MONTGOMERY COUNTY PLANNING DEPARTMENT
THE MARYLAND-NATIONAL CAPITAL PARK AND PLANNING COMMISSION

MEMORANDUM

REVIEW TYPE: Preliminary Plan Review

PROJECT NAME: Bannockburn Heights
CASE #: 120070390
REVIEW BASIS: Chapter 50, Montgomery County Subdivision Regulations

PRELIMINARY SUBDIVISION PLAN

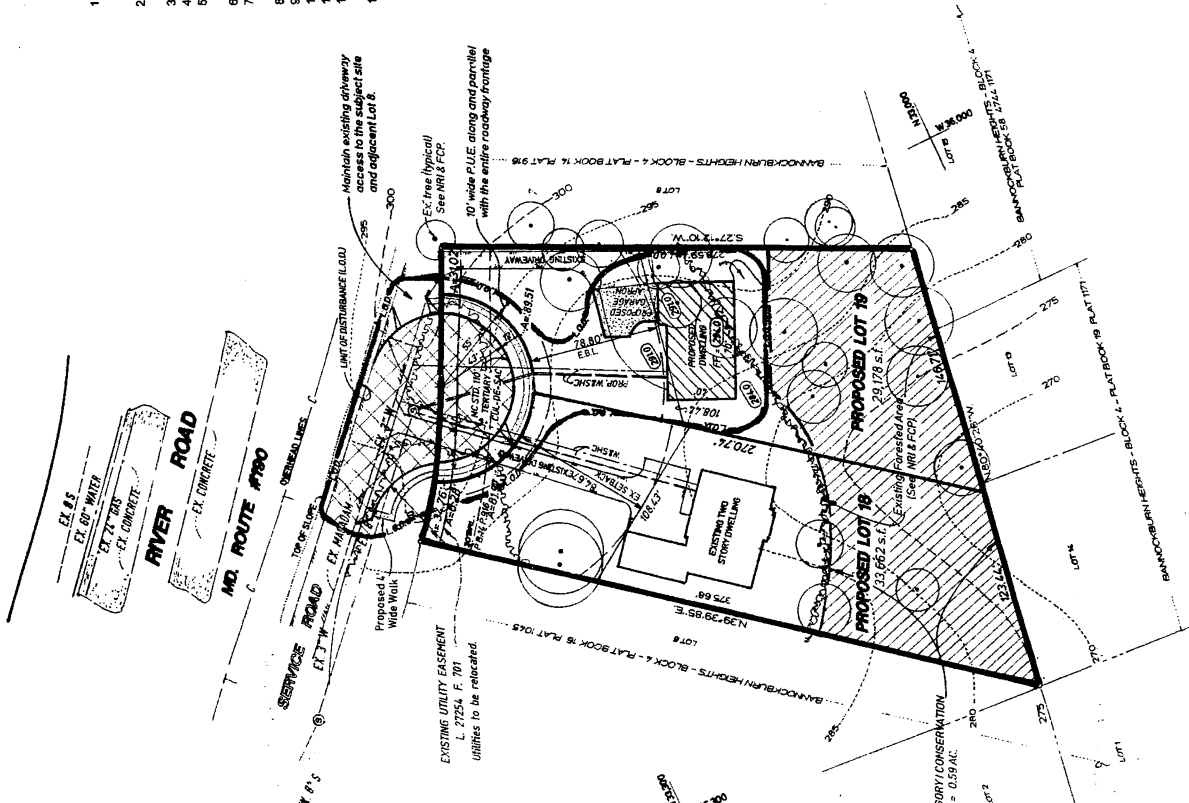
As previously mentioned, the applicant proposes to construct a cul-de-sac to terminate the River Road Service Road. The current design, however, has been modified from the April, 2004 version. Whereas specific termination of the service road was not required during earlier agency reviews of this resubdivision, that has now changed given Montgomery County Department of Fire and Rescue Services (MCFRS) active participation in the review, and their requirements for a turn-around for fire department access whenever there is a dead-end street longer than 150 feet, serving more than one house. Although such a turn-around could be provided by other non-public means, all staff agree that the proposed public cul-de-sac is probably the best option. The proposed dedication and design for the proposed cul-de-sac have been approved by the Department of Public Works and Transportation (DPWT), State Highway Administration (SHA) and MCFRS as shown on the plan.

A four-foot wide sidewalk around the cul-de-sac bulb in the right-of-way is required by DPWT as part of construction of the standard street section. They also recommended that the Planning Board require this applicant to construct an off-site sidewalk to connect the service road to Braeburn Parkway and River Road to the southeast. Staff determined that such an off-site improvement exceeded what could reasonably be required of this particular application given its size and scope.

In regards to tree removal, the applicant's plan shows a limit of disturbance that follows the edge of the existing service road to the northeast, and the edge of the proposed right-of-way line to the south. There may be existing trees that will be impacted, but staff is recommending as condition of approval for this application, that a tree protection plan be incorporated into the final forest conservation that shows and describes the methods that will be used to protect as many trees as possible. Maintenance of the cul-de-sac will be the responsibility of the Montgomery County Department of Public Works and Transportation (DPWT) once the road is constructed by

- 7) The Applicant must construct a four-foot-wide sidewalk along the proposed cul-de-sac as required by MCDPWT letter dated August 3, 2006, unless otherwise amended.
